Planning Commission Staff Report

Subject: Change of Zoning Vote Report

Petition: **P.Z. 10-2013 Schoettler Grove (2349 Schoettler Rd.)**

RE: P.Z. 09 & 10-2013 Schoettler Grove

SHEET NO.:
C1.1

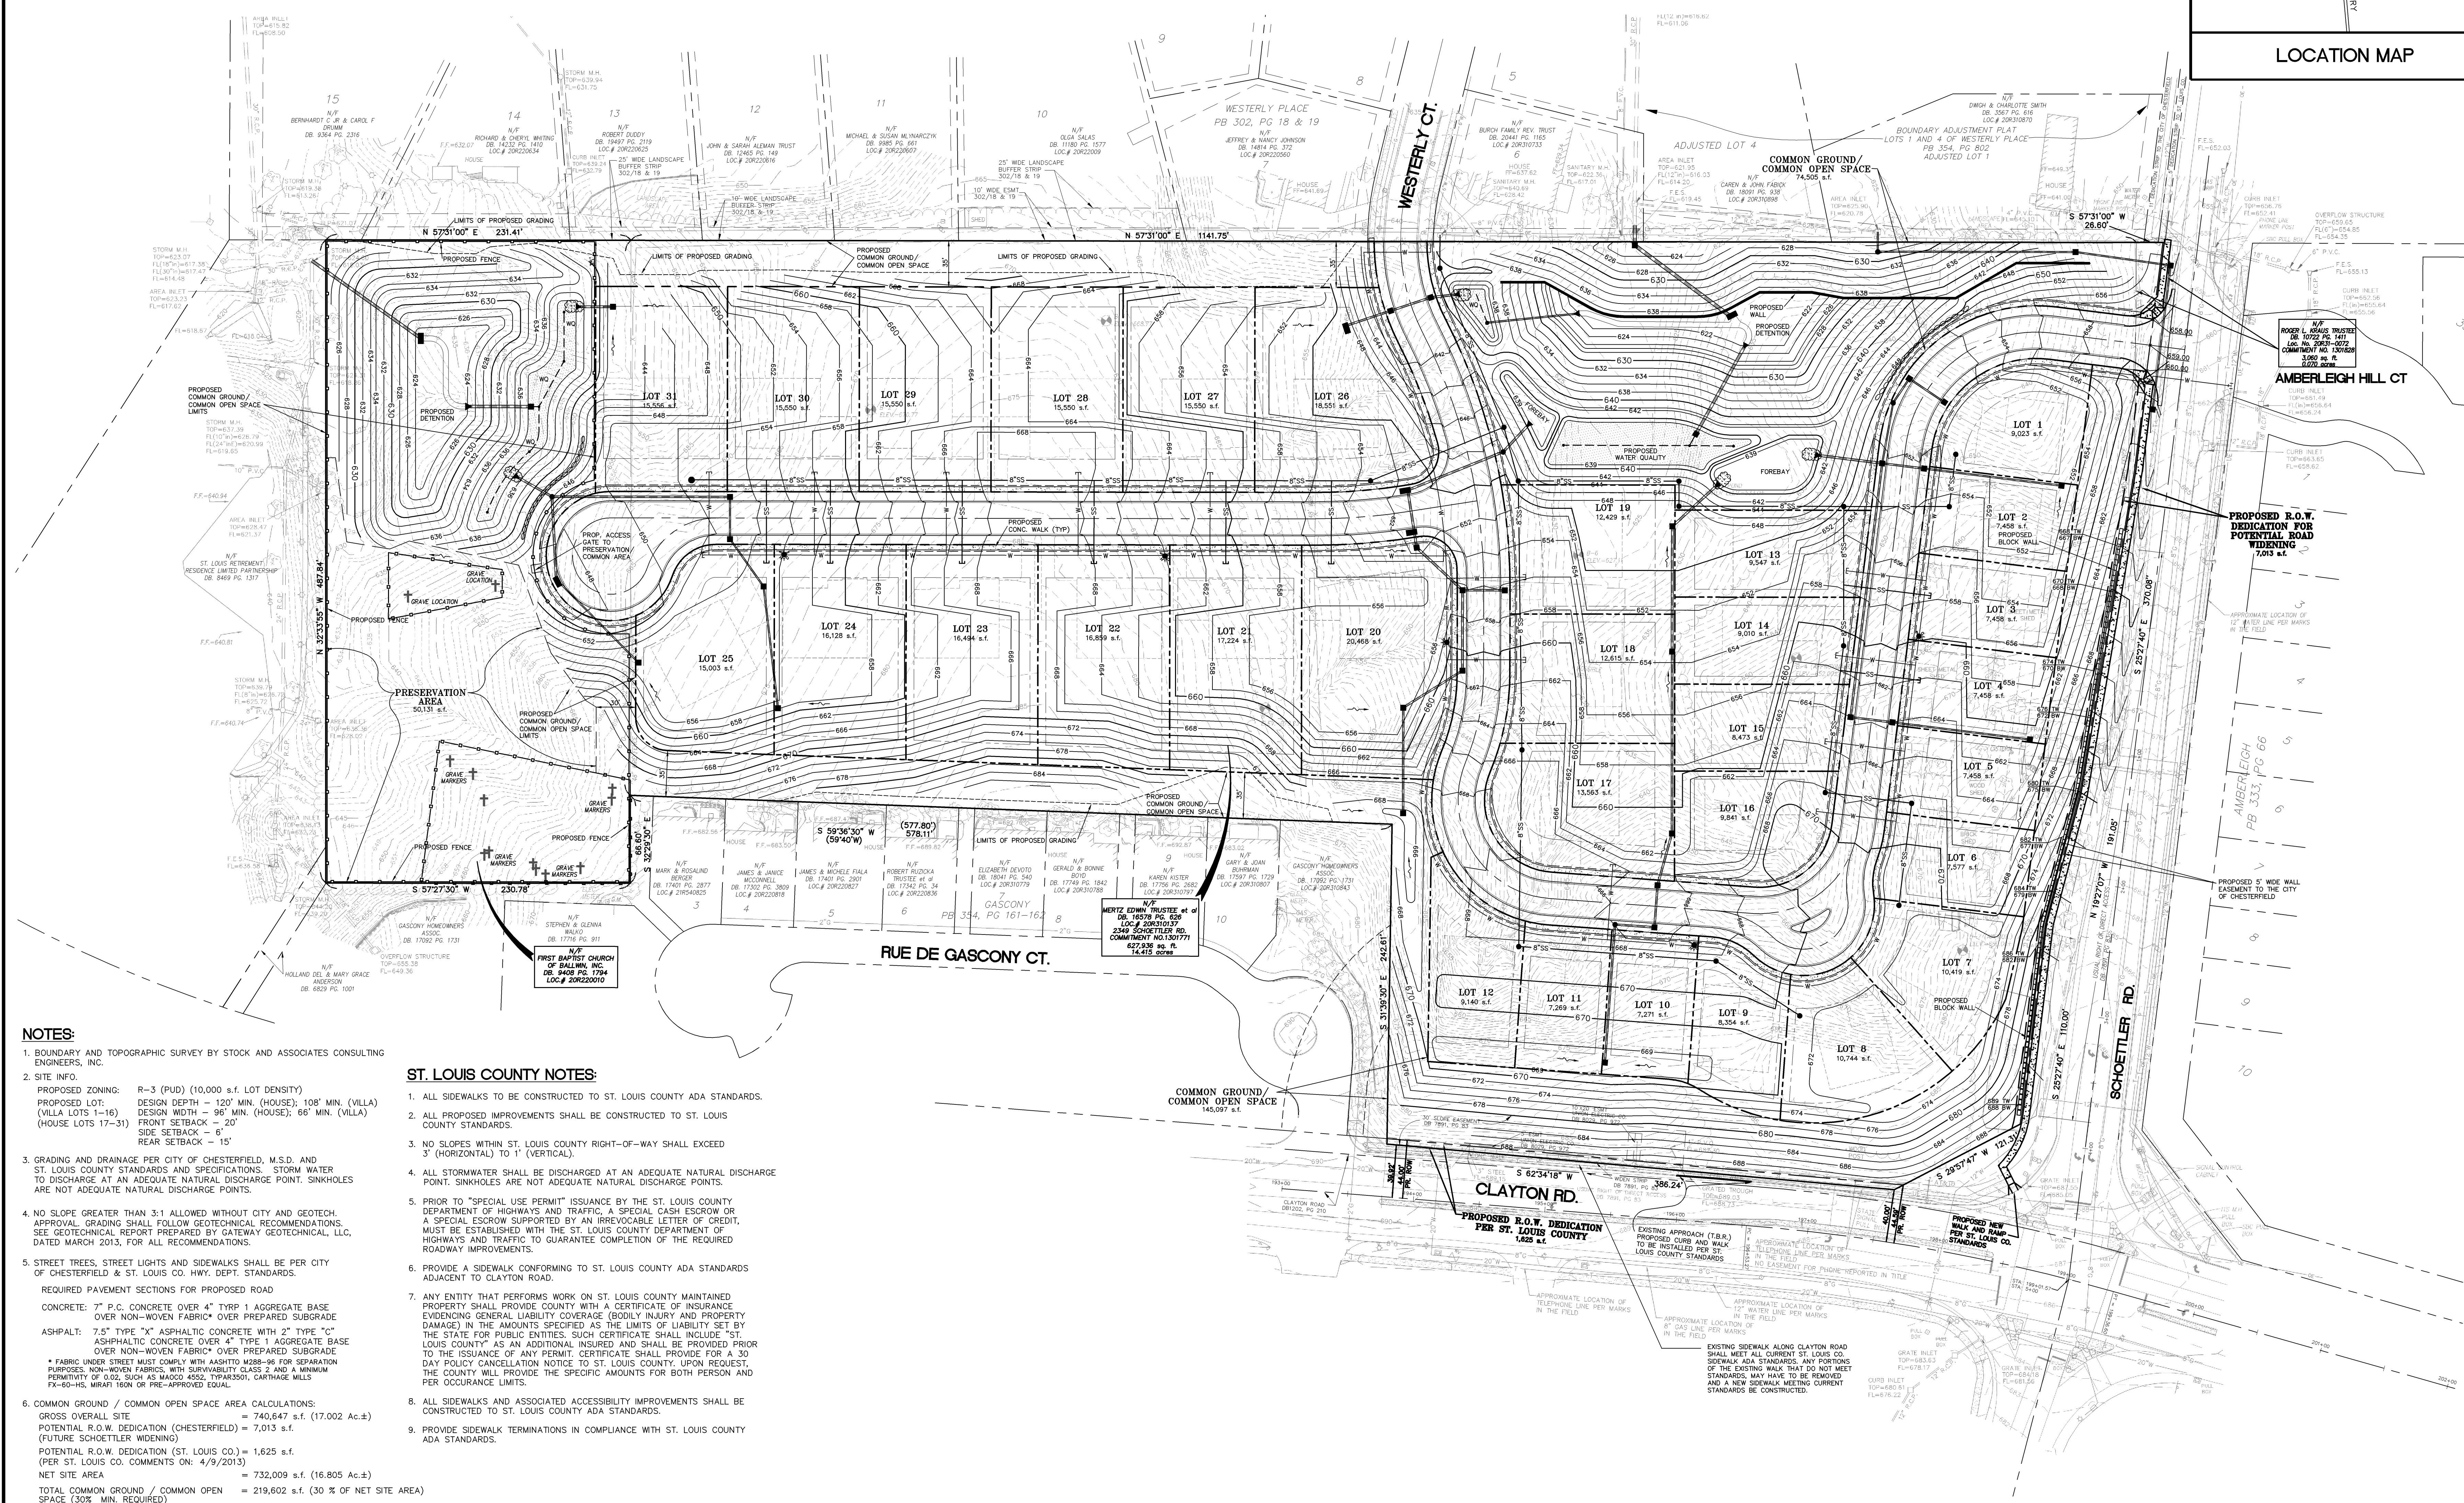
1. There is still a concern regarding the amount of existing landscaping and removal of natural buffering (berming) along the northern boundary of Schoettler Grove with Westerly Place. What additional steps can be taken to preserve the existing vegetation and berm and provide enhanced landscaping from what is currently proposed? What steps will be taken to create a visual buffer and separation between Schoettler Grove and Westerly Place so that individuals and residents know when they are leaving one subdivision and entering another?

2. Concern was expressed again regarding how this development is achieving the desired design aspects and intent of the PUD.

3. What preservation efforts can be taken to preserve additional tree massing throughout the site above what is currently projected to be preserved (specifically on the eastern section)?

4. What measures have been taken to ensure that all grave-markers have been identified and what measures will be taken if additional grave-markers are uncovered during construction?

5. How will future maintenance and preservation of the preservation area, including cemetery, be achieved? Be advised that this area is required to be maintained in perpetuity.

1. Remove the trail within the Preservation Area of the plan.

2. Currently the property located at 2297 Schoettler Road accesses the property from a driveway off of Schoettler Road. Provide on the preliminary plan a note that indicates if in the future this site redevelops, that cross access to this parcel from Schoettler Grove development could be achieved if directed by the City of Chesterfield.

As you are aware, Petitioner's development team has looked at a number of versions of a plan, and the revised Preliminary Plan submitted today represents substantial changes from the original submitted Preliminary Plan. Those changes were made to address the buffering and separation concerns. Since the last Planning Commission meeting, Petitioner's development team has looked at these concerns again. Further changes are not feasible or permissible because of the City's slope requirements and the topography of the site.

However, with respect to the separation concern, Petitioner has consistently maintained that a full access connection at Westerly Court is not necessary from Petitioner's perspective. Consequently, Petitioner would propose that Attachment A be amended to provide that the Westerly Court connection access be limited to emergency and street maintenance access purposes only, and Petitioner will install an appropriate gate and opening mechanism as directed by the Fire District and the City.

As stated in the response to No. 1 above, Petitioner's development team took another long look at this concern, but further changes in this area are not feasible or permissible because of the City's slope requirements and the topography of the site.

Members of Petitioner's development team have physically inspected the site and consulted with representatives of the African-American Church that owns the site. The team believes all grave-markers have been located. However, in view of the concern, Petitioner has determined not to locate any trails within the site but simply treat it as a completely fenced Preservation Area that will be maintained in its natural state after initially cleaning up the Preservation Area.

The Preservation Area will be maintained in its natural state after initial cleanup. Periodic cleanup and removal of dead and downed plants and trees will be accomplished by a Homeowner's Association which will be funded by assessments.

The trail is not shown on the revised Preliminary Plan.

The Petitioner agrees, and the note is on the revised Preliminary Plan.

Sheet Title: **Tree Stand Delineation**
Sheet No: **TSD-1**
Date: **7/26/13**
Job #: **100.013**

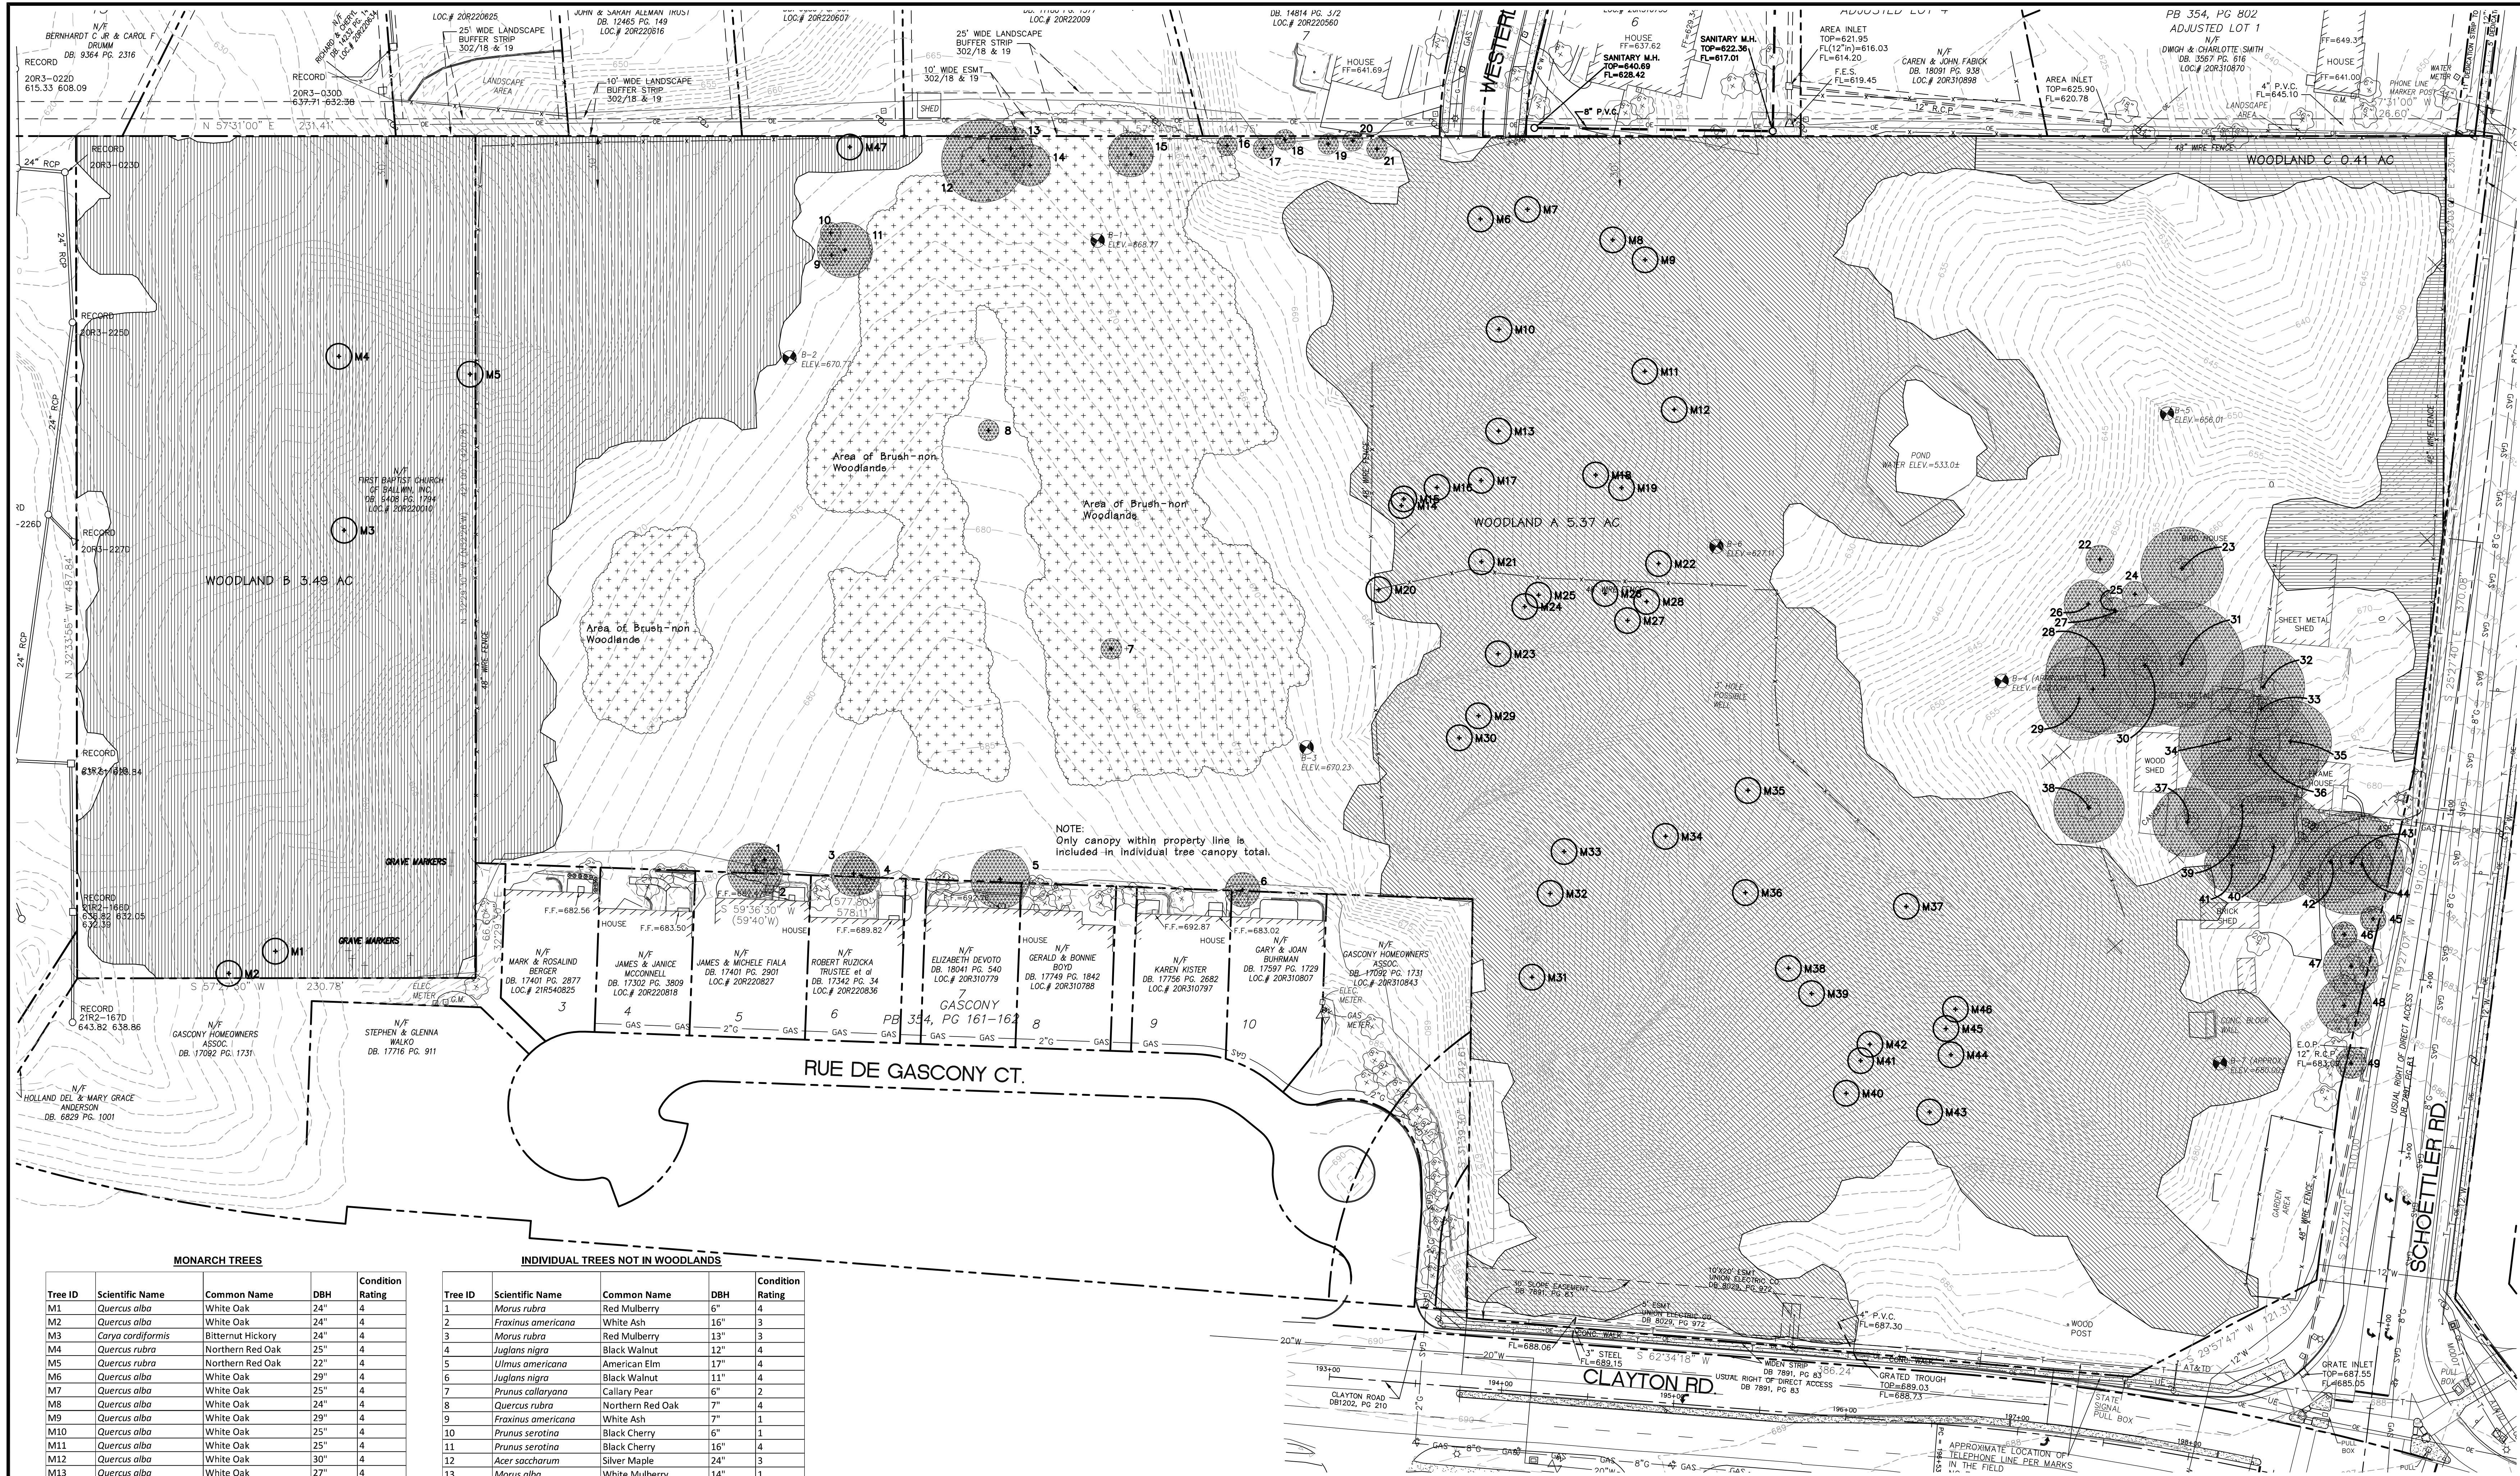
Lastly, although staff has concluded that the new Tree Stand Delineation Plan meets the requirements of the Tree Preservation and Landscape manual, it is still significantly inaccurate by omission.
